Night lighting plan

Our ref: 104101-01

Re: Valley of the Winds – Wind Turbine Obstacle Lighting

Figure 1 - Overall view of proposed obstacle lighting layout

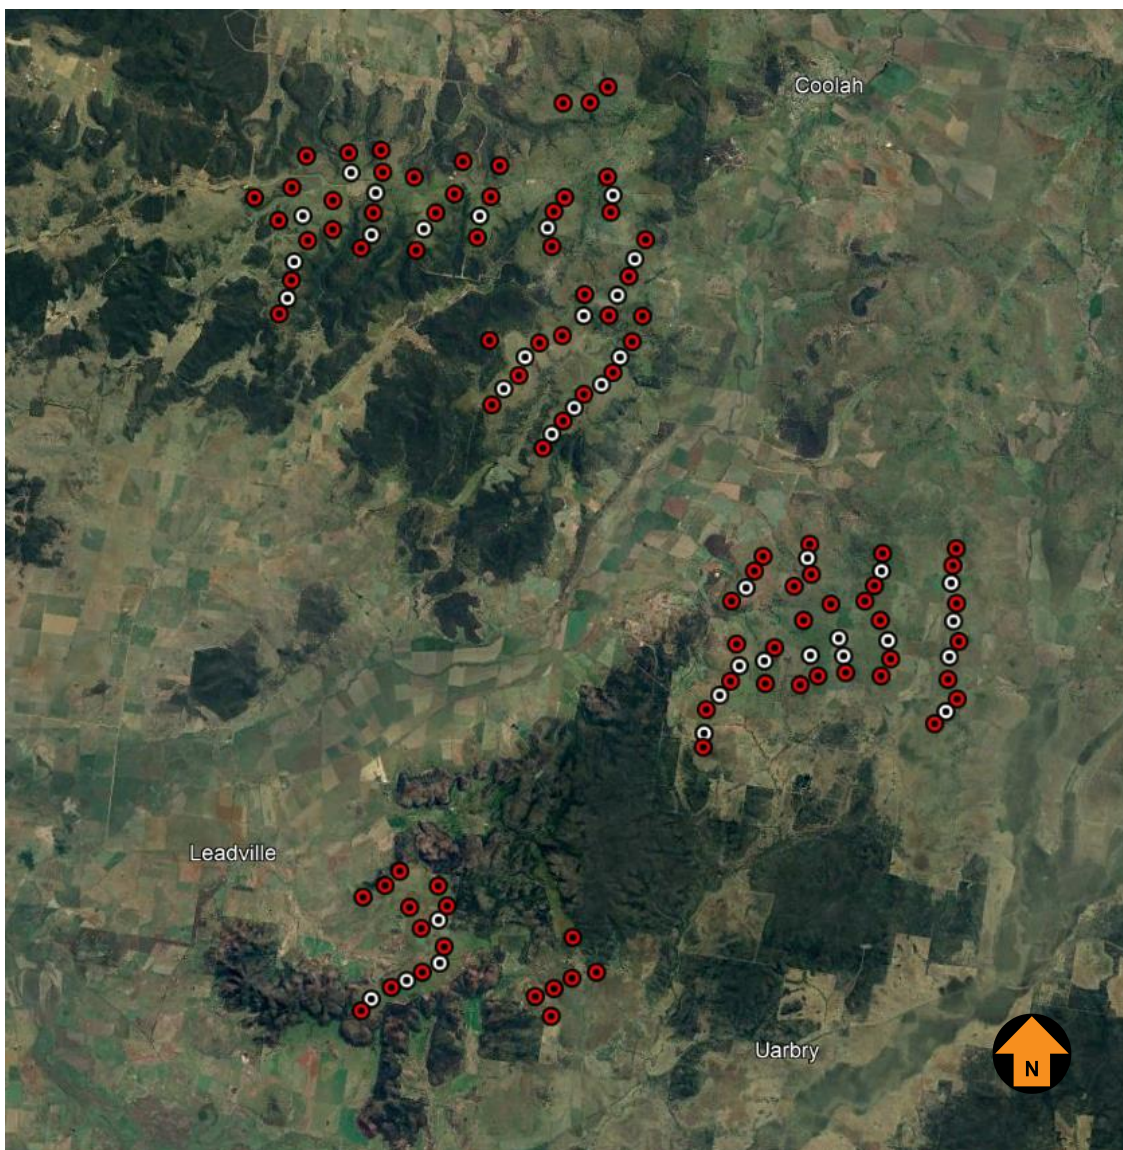
Due to the height proposed AGL, CASA considers the proposed wind farm likely be a hazard to aviation safety and recommends that the wind farm is obstacle lit. While international standards and the NASF guideline recommend 2,000 candela lighting intensity, CASA would accept 200 candela lighting intensity based on trial installation at another site where 200 CD was found to be sufficient in areas with low backlighting.

To minimise lighting impact on local residents CASA would also recommend the installation of radar activated hazard lights or lighting activated by low visibility measuring equipment. If the lighting fails, it should fail in the 'on' condition until it can be rectified.

Based on CASA's advice and the guidance in NASF Guideline D relating to obstacle lighting on wind turbines, it is suggested that the nominated wind turbines in the Valley of the Winds Wind Farm have 200 cd low intensity steady red obstacle lighting, as illustrated in the following Figures.
